Well Name: JRU APACHE FEDERAL COM	Well Location: T22S / R30E / SEC 13 / SESE / 32.386159 / -103.828575	County or Parish/State: EDDY / NM
Well Number: 802H	Type of Well: OIL WELL	Allottee or Tribe Name:
Lease Number: NMNM89051	Unit or CA Name:	Unit or CA Number:
US Well Number: 3001555782	Operator: XTO PERMIAN OPERATING LLC

Sundry ID: 2827465

Type of Submission: Notice of Intent	Type of Action: APD Change
Date Sundry Submitted: 12/13/2024	Time Sundry Submitted: 12:40
Date proposed operation will begin: 12/27/2024

PECOS DISTRICT DRILLING CONDITIONS OF APPROVAL

Figure B – 3 String Design – Open Production Casing Annulus (Updated May 2024):

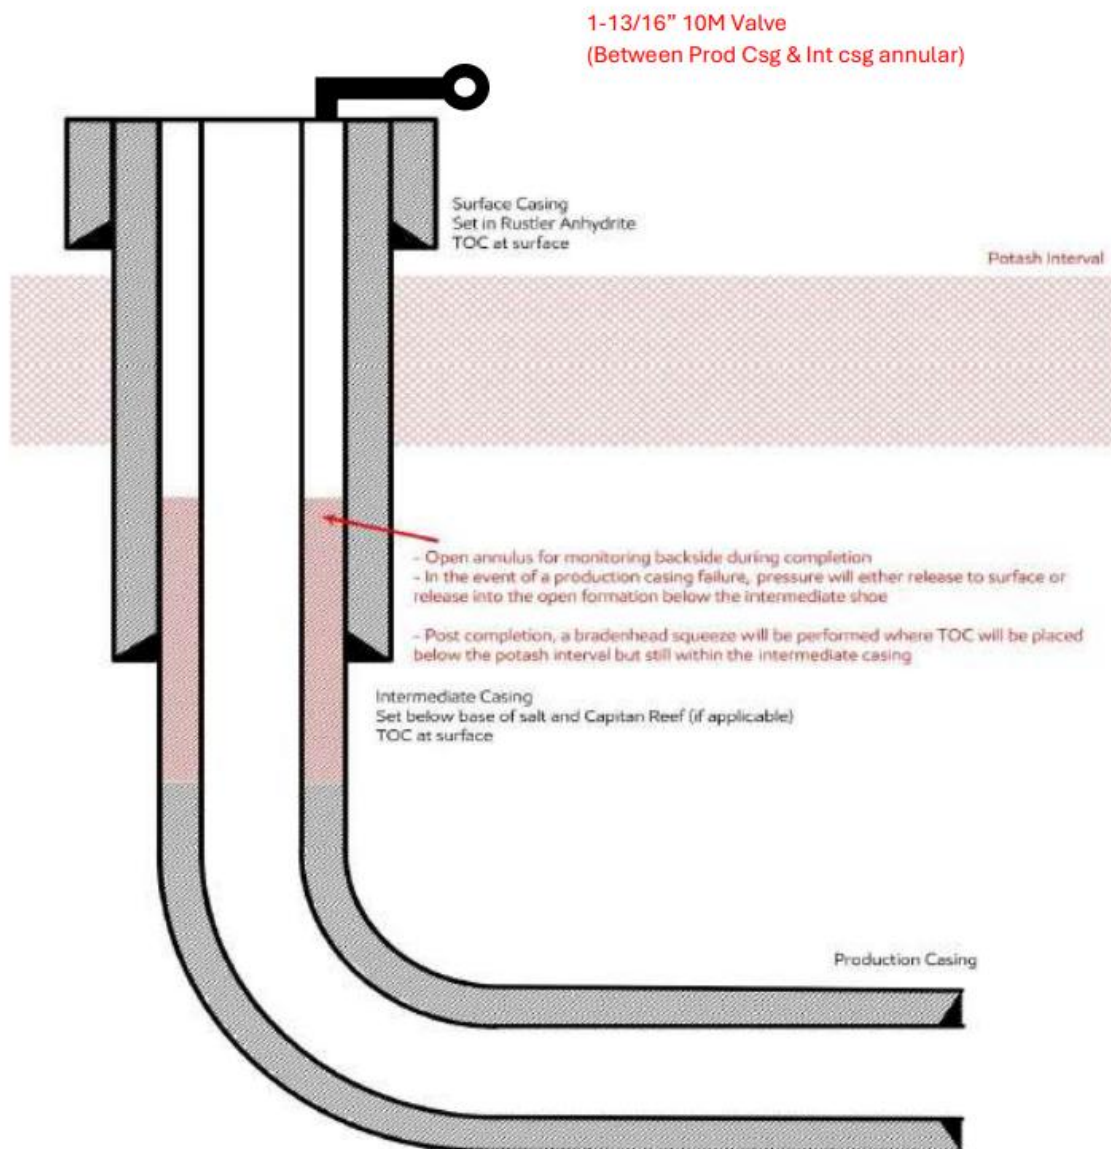
XTO is aware of the R-111-Q update & will comply with these requirements including (but not limited to):

1. Alignment with KPLA requirements per schematic above, leaving open annulus for pressure monitoring during frac and utilizing new casing that meets API standards
2. Contingency plans in place to divert formation fluids away from salt interval in event of production casing failure
3. TOC in the annulus between intermediate & production casing string shall stand uncemented at least 500 feet below the intermediate casing shoe
4. Bradenhead squeeze to be completed within 180 days after hydraulic frac operations have been concluded to ensure at least a 500 feet tie-back has been established inside salt string but with top below MB 126

- ❖ **A monitored open annulus will be incorporated during completion by leaving the Intermediate Casing x Production Casing annulus un-cemented and monitored inside the Intermediate String.** Operator must follow monitoring requirements listed within R-111-Q. Tieback requirements shall be met within **180 days**.

Operator has proposed to pump down **intermediate x production** annulus post completion. **Operator must run Echo-meter to verify Cement Slurry/Fluid top in the annulus OR operator shall run a CBL from TD of the production casing to surface after the second stage BH to verify TOC.** Submit results to the BLM. No displacement fluid/wash out shall be utilized at the top of the cement slurry during second stage bradenhead when running Echo-meter if cement is required to surface. Adjust cement volume and excess based on a fluid caliper or similar method that reflects the as-drilled size of the wellbore.

Operator has proposed an open annulus completion in R-111-Q. Operator shall provide a method of verification pre-completion top of cement. **Submit results to the BLM. Pressure monitoring device and Pressure Safety Valves must be installed at surface on both the intermediate annulus and the production annulus for the life of the well.**
